NCR/FM/INFN/RM2/1

<i>Classification</i>	<i>Item name</i>	<i>Found on:</i>
major	fid-Tray Composite Panel Assembl	06/18/2004 4:13:41 PM

Short NCR description Bias circuits delaminations

ANNEX 1 to NCR/FM/INFN/RM2/001

Tray Mid 006:

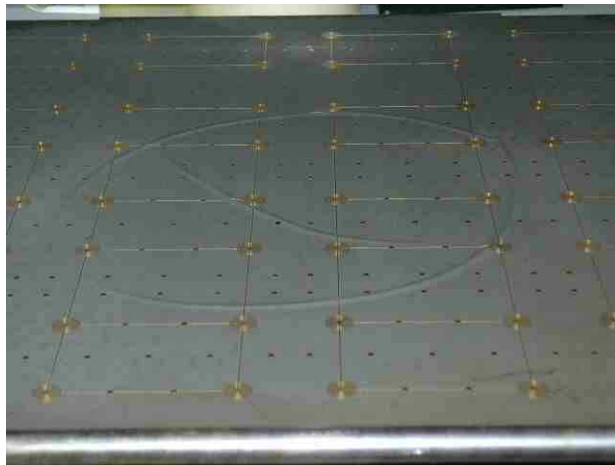
The following images shows the effect of the test on the trays Mid 006, Mid 008, Mid 015.

Mid008 Top Surface

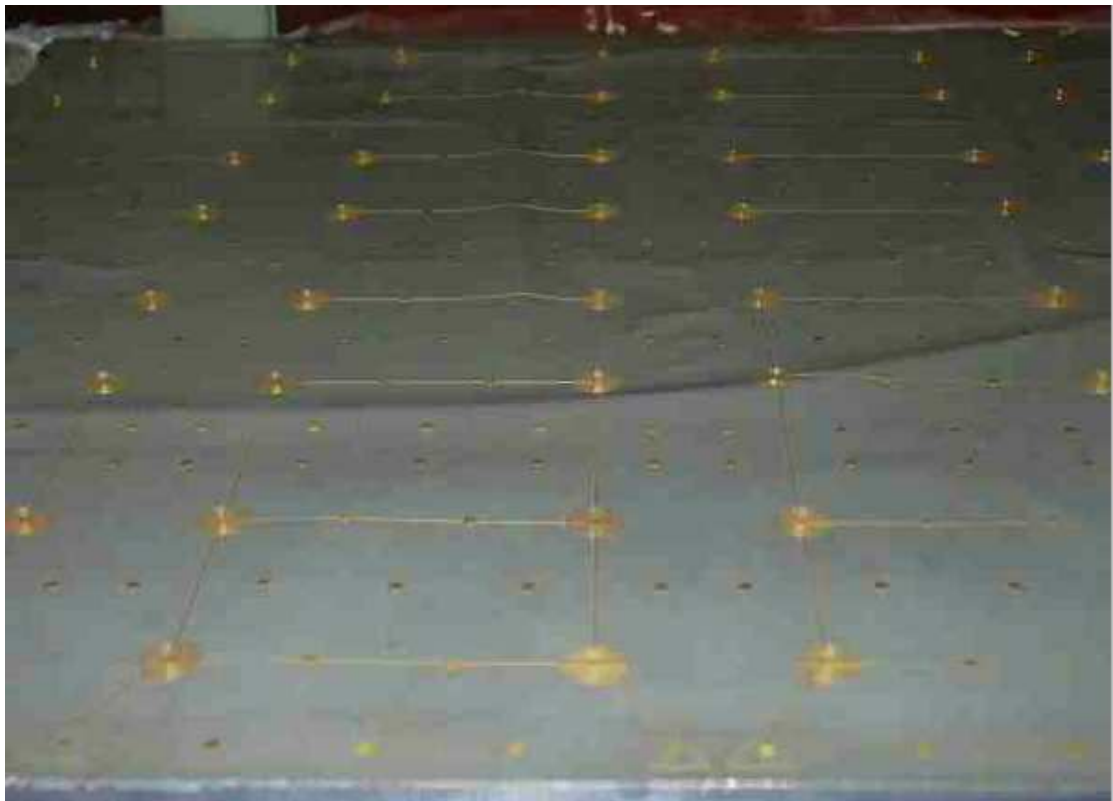
The Thermo Vacuum Test of the trays Mid006, Mid008, Mid015, failed. The bonding between the Bias Circuit Foils and the panels relaxed and the foils showed a large surface wrinkling (see picture 1, 2, 3, 4):

These large debonding areas seem induced by the CTE differences between Cu shield layer ($CTE = 17 \cdot 10^{-6} 1/^\circ C$) and the tray ($CTE \approx 0$). The Shear Stress overcame The shear strength of the adhesive with regular and uniform deformations.

We suggest to decrease the Peak temperature of the Thermo Vacuum test of the trays from $85^\circ C$ to $55^\circ C$, $5^\circ C$ Higher than the requested max temperature as for LAT-TD-03651.

- 1) Vacuum test of 4 trays at room temperature
- 2) If no debonding will be observed, perform a Vacuum test @ $55^\circ C$ for 4 hours
